Subject: SQUEAKING NOISE FROM FRONT SUSPENSION WHEN PASSING OVER A BUMP	Bulletin No: 02-002/06
	Last Issued: 3/22/2006

2004-2006 Mazda3 vehicles with VINs lower than JM1 BK**** ** 483440 (produced before January 27, 2006)

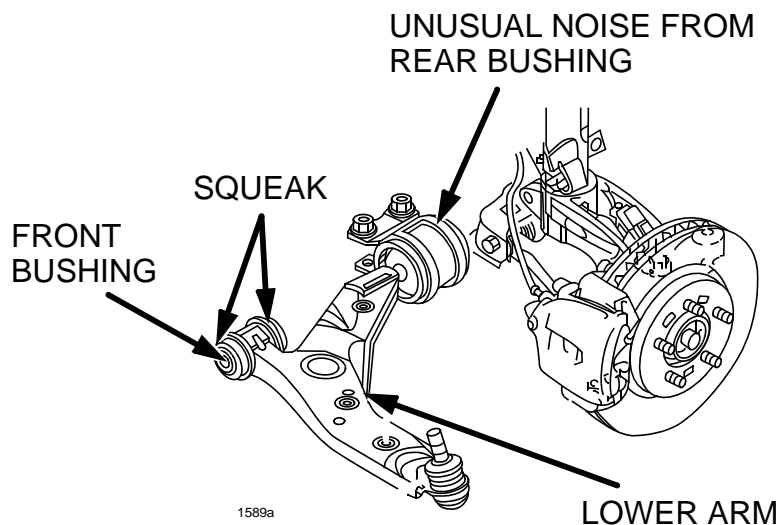
Some vehicles may exhibit a squeaking noise from the front suspension when passing over a bump at a low speed. This is may be caused by one of the following.

- The front lower arm making contact with the bushing, causing a squeaking noise.
- The fluid in the rear bushing makes an unusual noise.

1. Verify customer concern.
2. Replace front lower arm. Refer to appropriate Workshop Manual section 02-13 - FRONT LOWER ARM REMOVAL / INSTALLION.
3. Perform toe-in inspection and adjustment. Refer to appropriate Workshop Manual section 02-11 - WHEEL ALIGNMENT.

Part Number	Description	Qty.	Notes
B32H-34-300D	Lower Arm Assembly (R)	1	---
B32H-34-350D	Lower Arm Assembly (L)	1	---
